**BOARD OF ZONING ADJUSTMENT
STAFF REPORT****Date: August 3, 2020****CASE NUMBER**

6336/6162

David M. Shumer (Barton & Shumer Engineering, LLC)

VARIANCE REQUEST

SITE PLAN

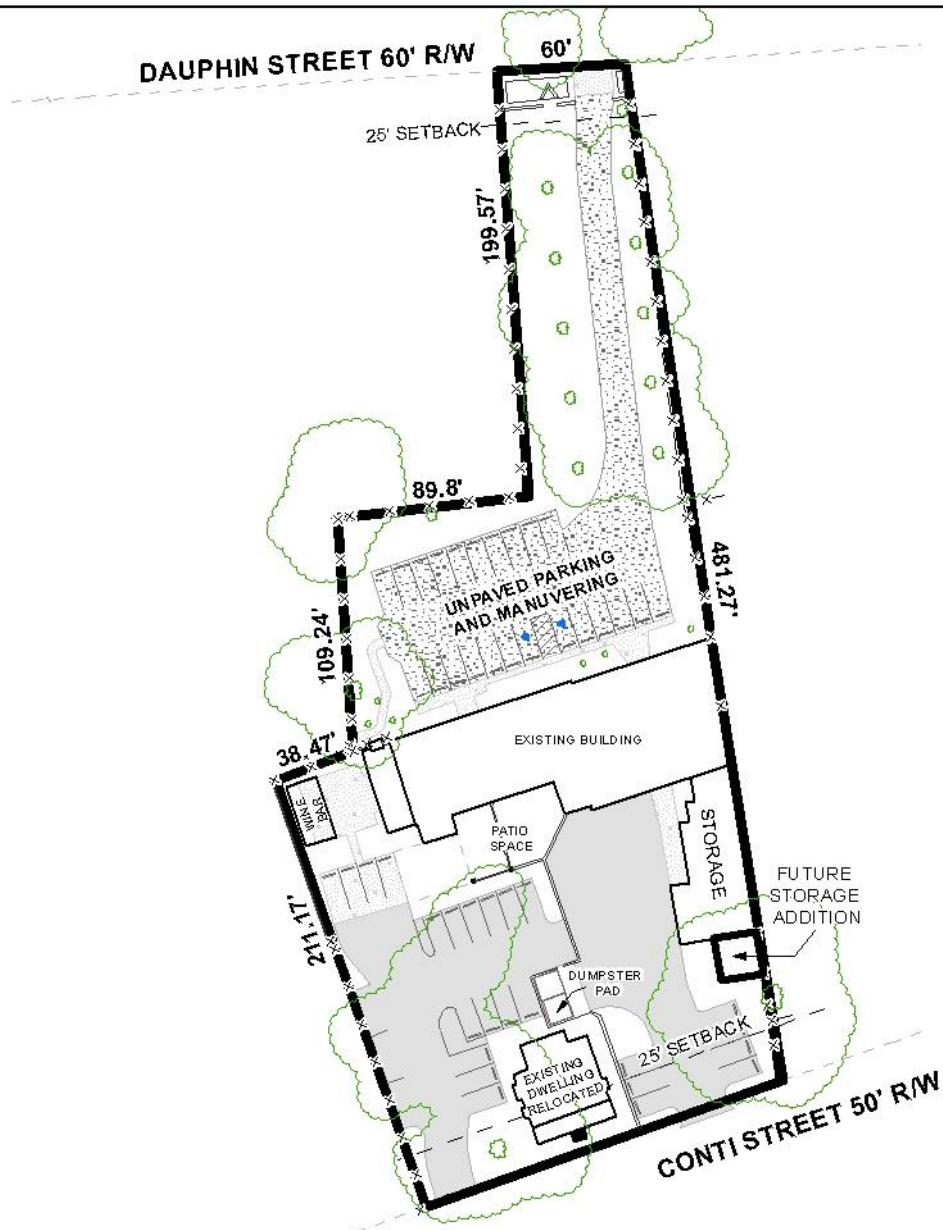
If the aggregate surfacing is approved for use the applicant
will need to have the following conditions met:

1. Submit and receive a Land Disturbance Permit through Central Permitting for the proposed site development.
2. Submit a ROW Permit (City of Mobile) for the work within the Public ROW. Aggregate surfacing will NOT be allowed within the public ROW.
3. Designated handicapped accessible spaces and routes must be paved (i.e. concrete, asphalt).

Aggregate surface, if approved, shall not extend into the right of way. Required on-site parking, including ADA handicap spaces, should meet the minimum standards as defined in Section 64-6 of the City's Zoning Ordinance.

All projects within the City Limits of Mobile shall comply with the requirements of the City of Mobile Fire Code Ordinance. (2012 International Fire Code). Fire Code compliant paved access required from both streets.

Concerning the aggregate parking and access/ maneuvering surface request, the requirement to have paved access/maneuvering aisles is not only a Zoning Ordinance requirement, but a Fire Code requirement as well. Paved drive aisles are required to allow the fire trucks to properly access a structure in case of a fire or emergency. The applicant states the reasons for the request are “to maintain the character of the historic structure and minimize the storm water runoff from the north side of the building”. However, the use of the property is changing and by adding an

Aggregate surfaces are frequently utilized in the historic areas of the City and the site is located within the Old Dauphinway Historic District; however, Fire Department access and handicap accessible parking should in paved with asphalt or concrete.

1. the provision of compliant paving for fire department access;
2. the provision of paved handicap accessible parking; and
3. full compliance with all municipal codes and ordinances
